UNITED STATES PATENT AND TRADEMARK OFFICE

APPLICATION NO.	FILING DATE	FIRST NAMED INVENTOR	ATTORNEY DOCKET NO.	CONFIRMATION NO.
10/849,378	05/20/2004	Koichi Miyachi	1035-510	6503
23117	7590	09/12/2006	EXAMINER	
NIXON & VANDERHYE, PC 901 NORTH GLEBE ROAD, 11TH FLOOR ARLINGTON, VA 22203			CHIEN, LUCY P	
			ART UNIT	PAPER NUMBER

DETAILED ACTION

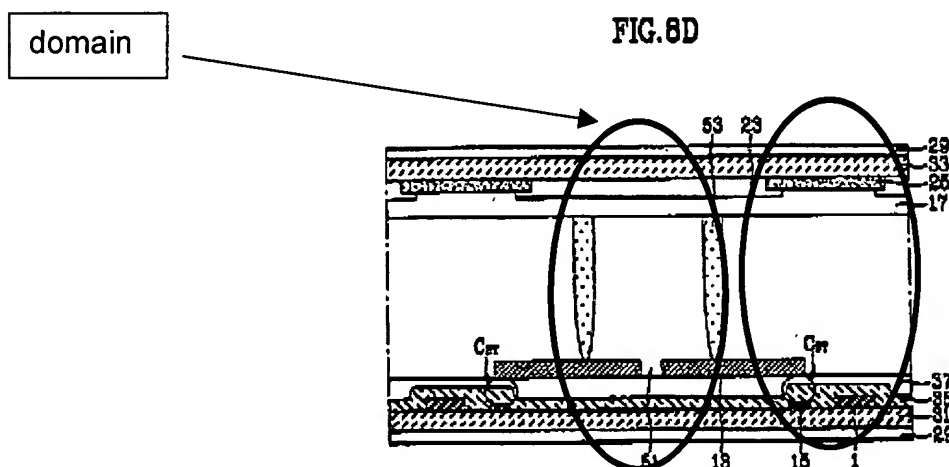
Regarding Claim 1,24,20

Kim et al discloses (Figure 8D) a pair of substrate (31,33) respectively having electrodes (17,13) on opposing surfaces, the pair of substrates sandwiching a liquid crystal layer (the space between 17 and 13).

A plurality of domains (shown below) formed within a display region when a voltage is applied to the electrodes, the plurality of domains being such that liquid crystal molecules are aligned in different directions from domain to domain, at least one of the electrodes on the pair of substrates having an aperture section (shown below). The liquid crystal layer having a plurality protrusion section (53) which connects the electrodes (17,13)

Kim et al further discloses (Figure 8D) at least one of the electrodes (13) has a protrusion (53) as the protrusion section within the display region; and a height of the protrusion is identical to a thickness of the liquid crystal layer (shown above).
